TECHNICAL DRAINAGE STUDY RESPONSE TO COMMENTS

TROPICAL PKWY/CENTENNIAL PKWY ROADWAY IMPROVEMENTS

Re: **Technical Drainage Study for Tropical Pkwy./Centennial Pkwy. Roadway
Improvements
CNLV No. 43988**

The purpose of this letter is to address comments contained in the November 30, 2011 review memorandum prepared for the above referenced project. The comments are addressed as follows:

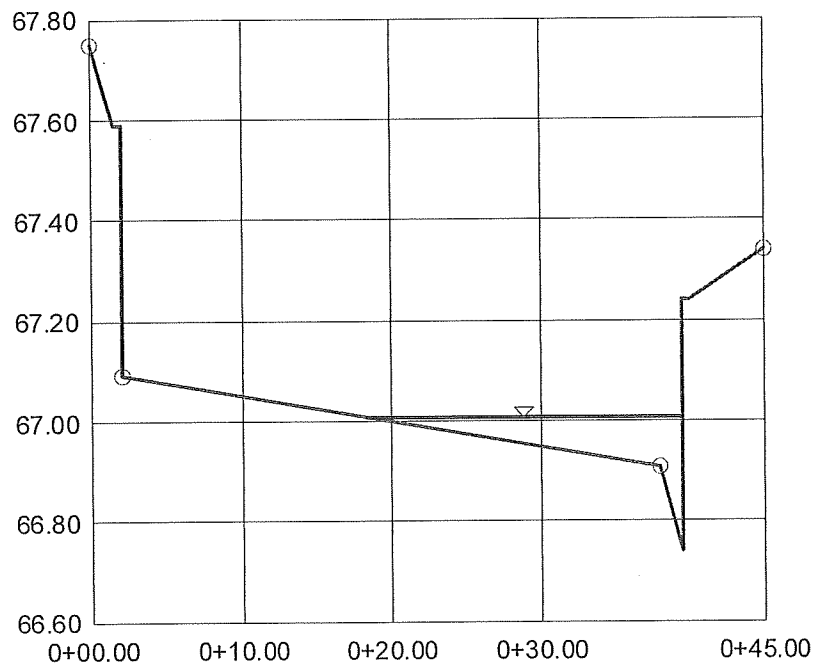
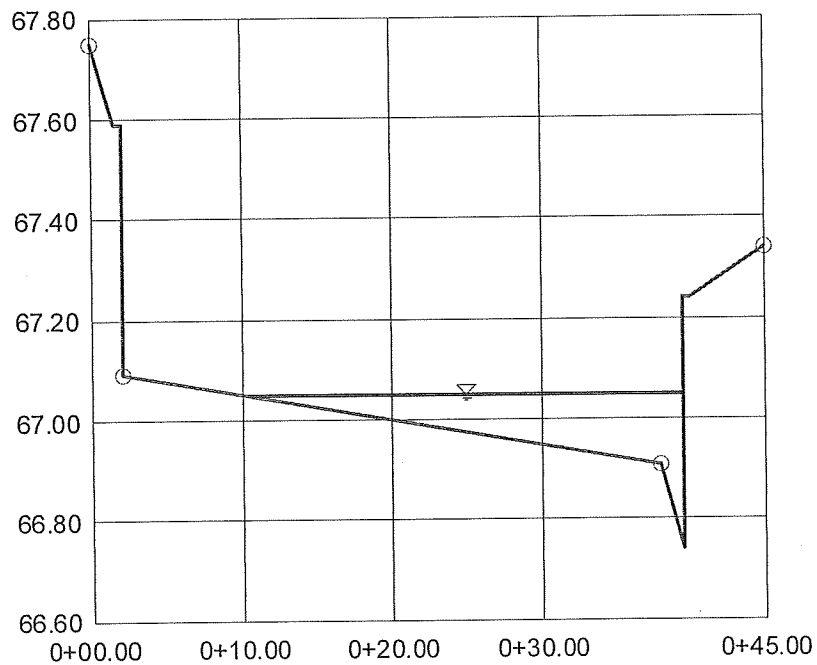
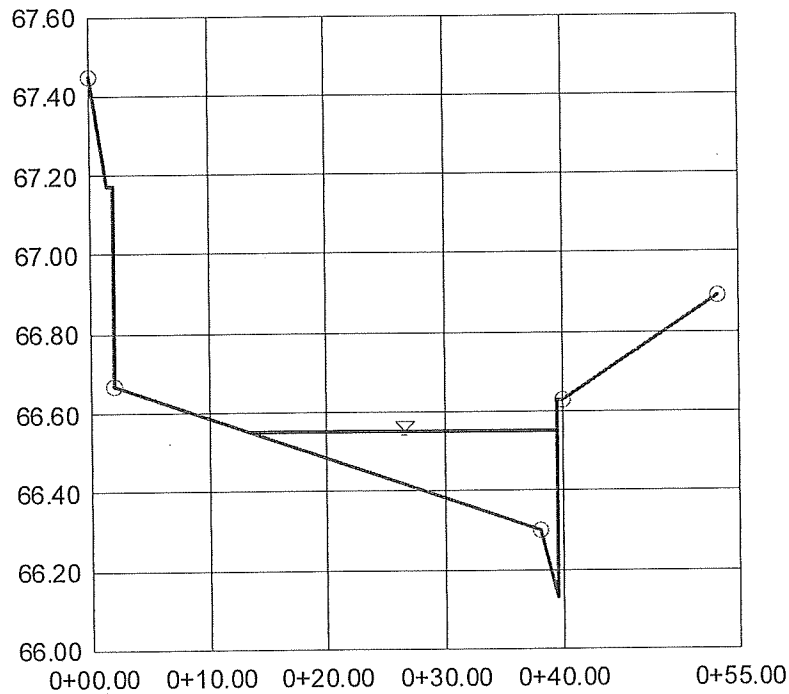
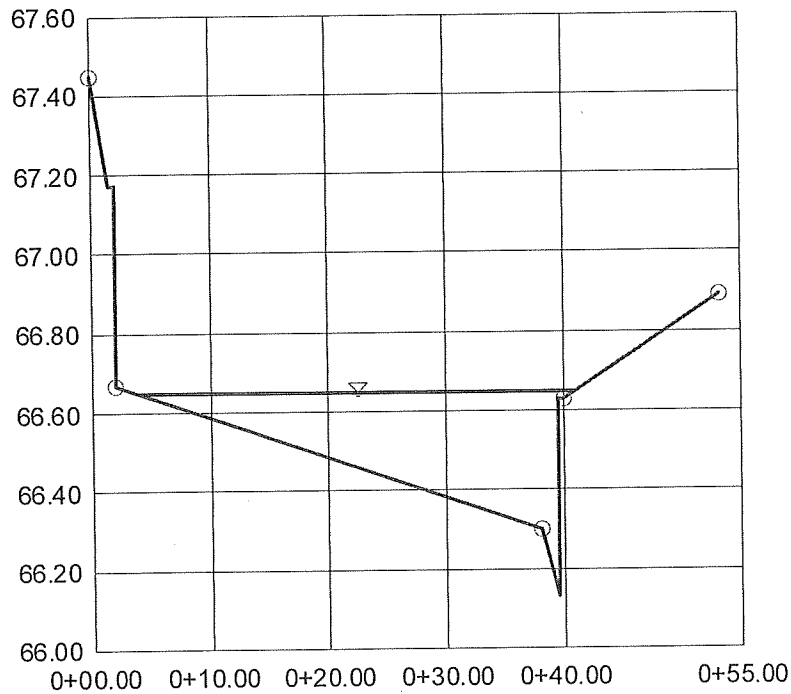
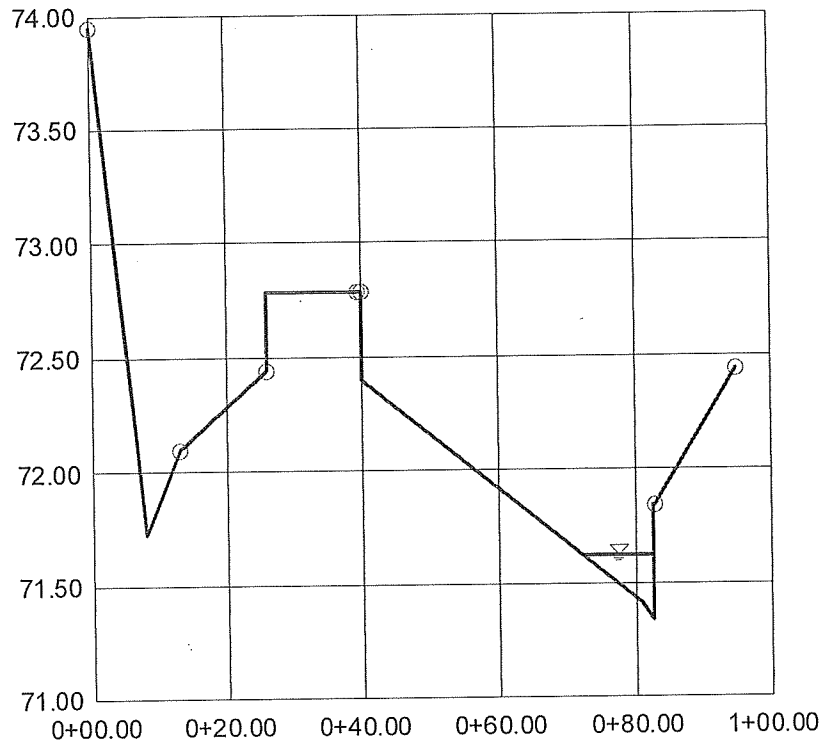
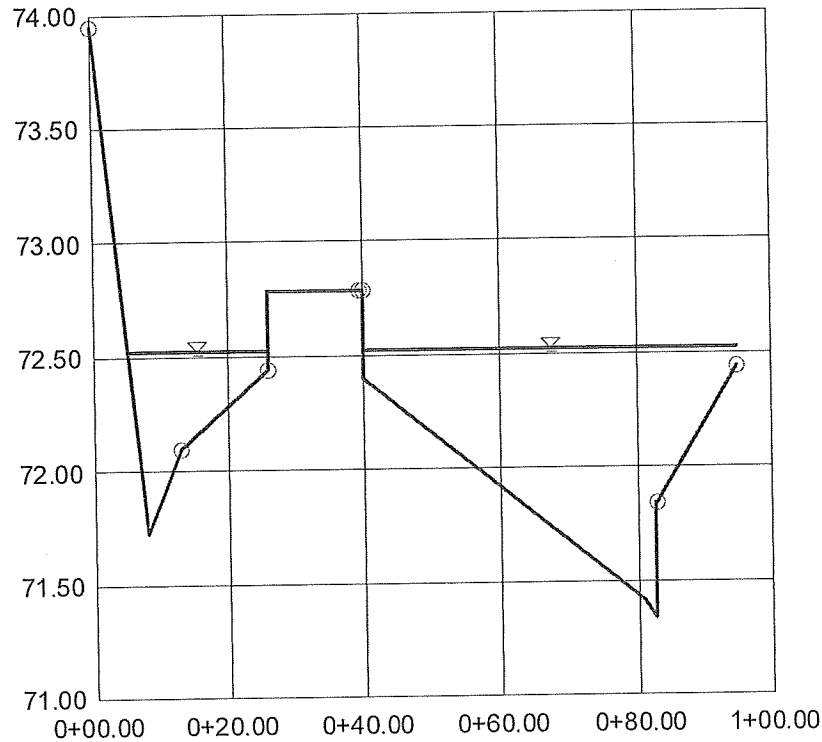
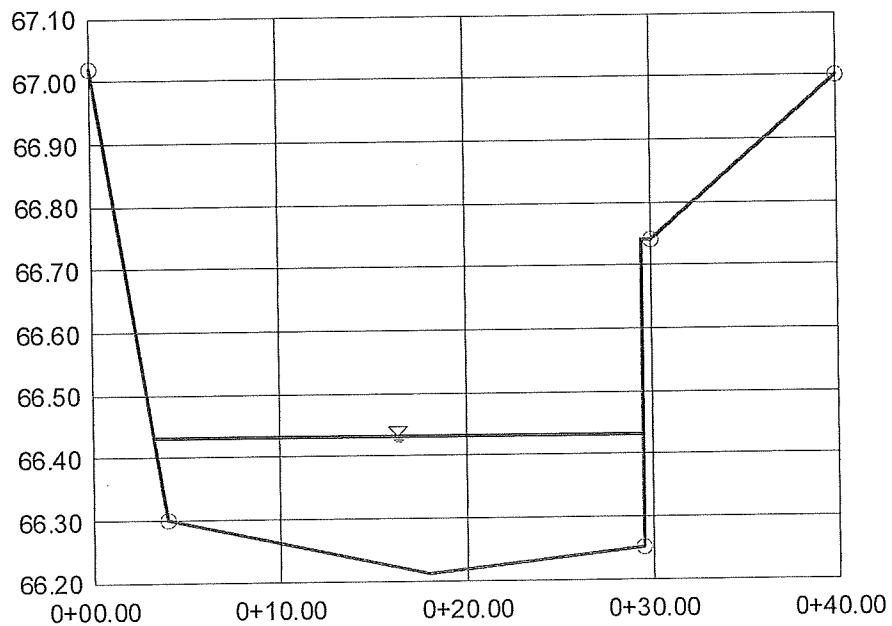
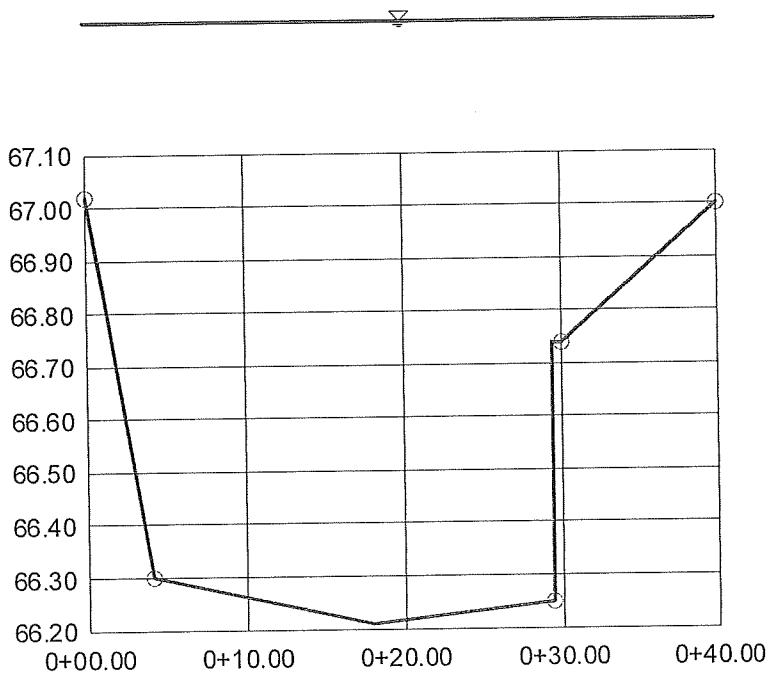
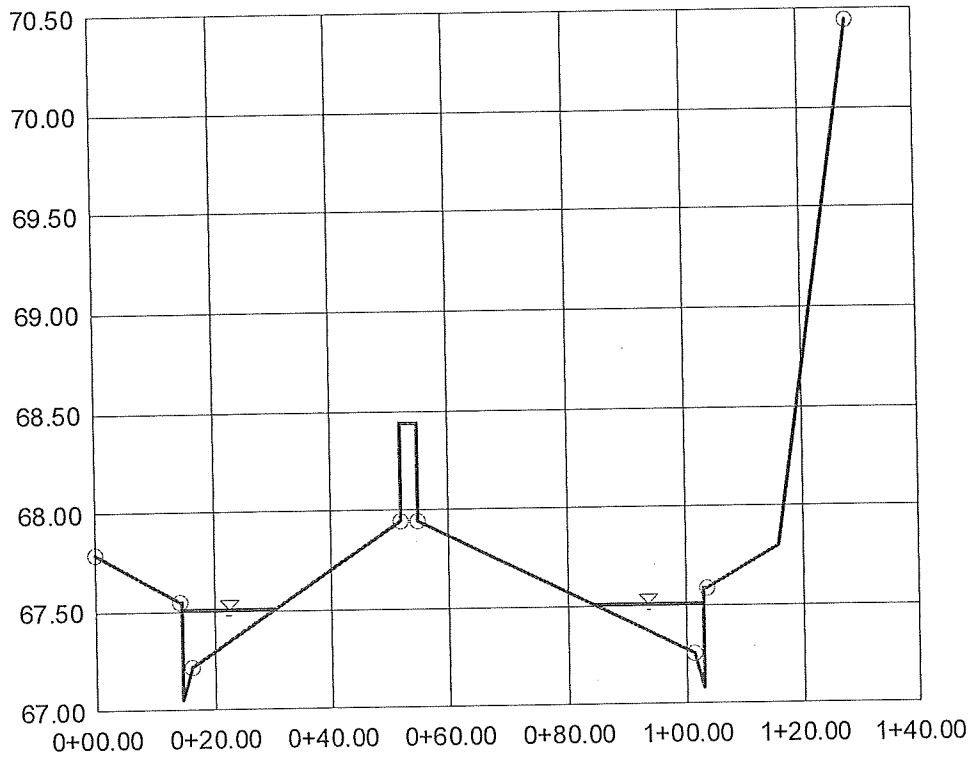
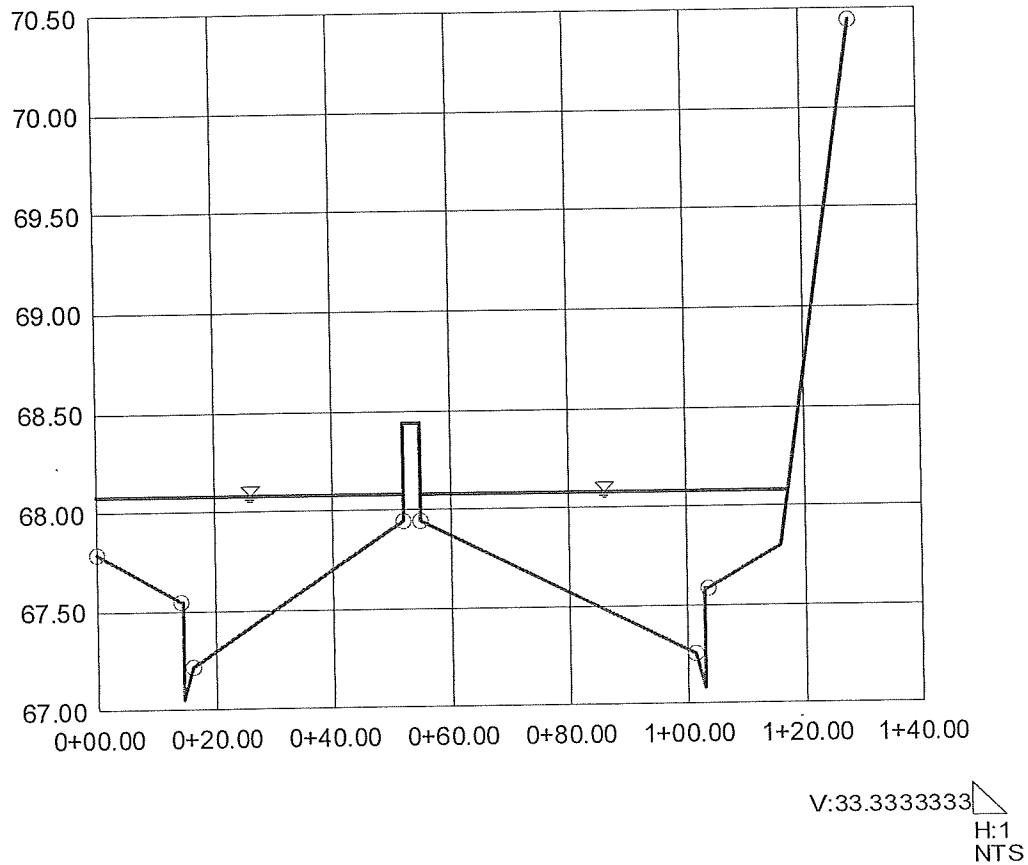
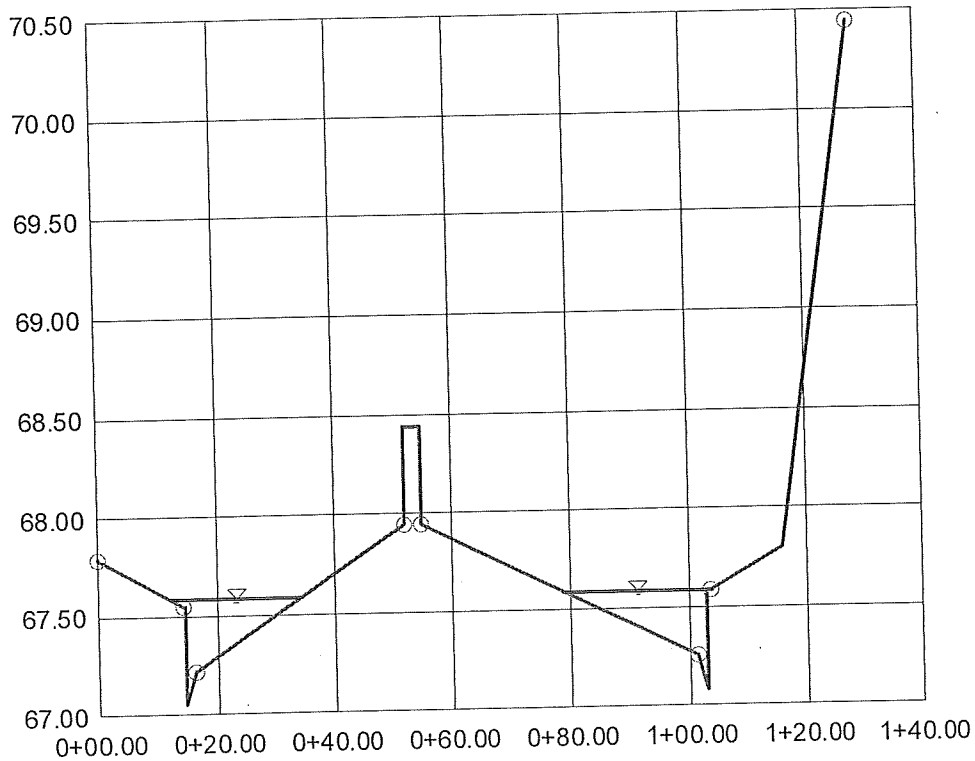
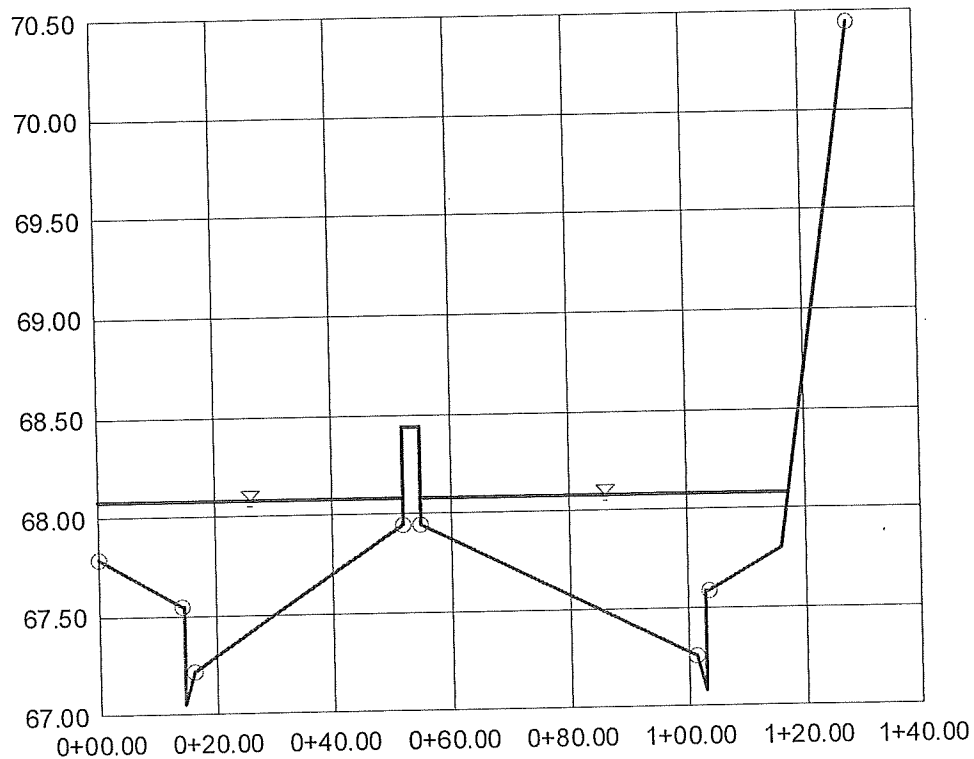
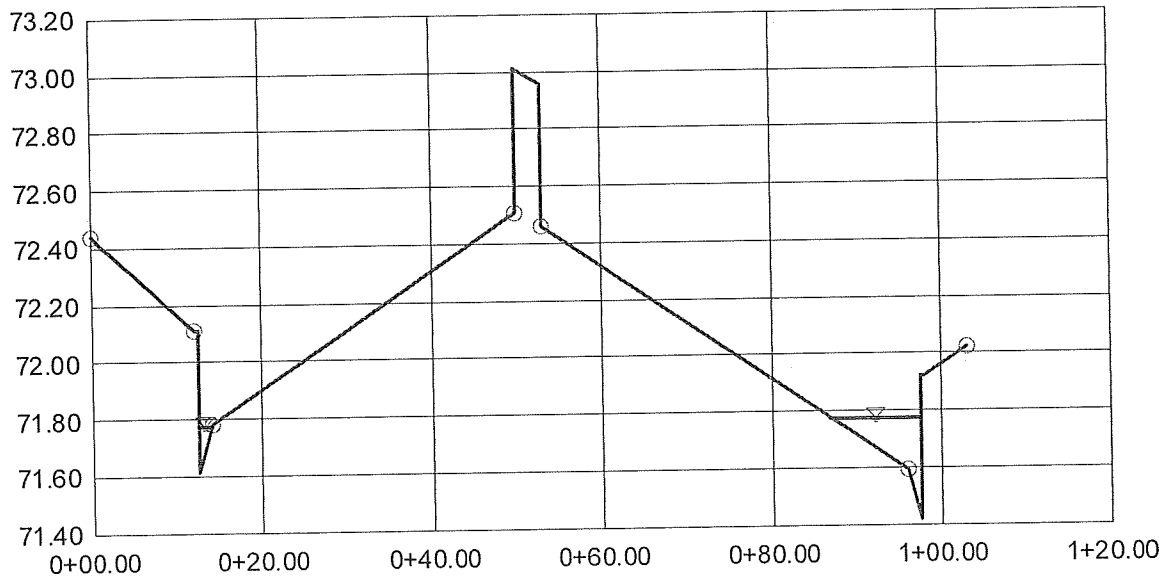
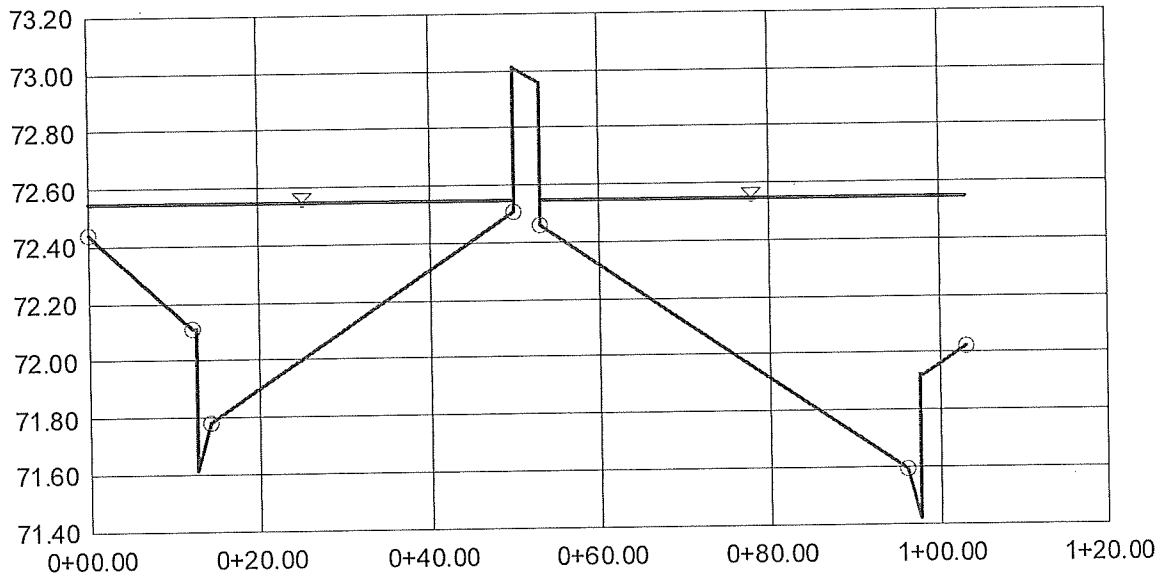
- 10. Comment:** Please revise the Flowmaster calculations for the interim and future conditions of Centennial Parkway and Tropical Parkway to show the proposed concrete median islands.

Response: Noted. Please refer to Appendix F for the revised worksheets. All street flow calculations have been revised to the current values. Street sections have been revised to include the center median.
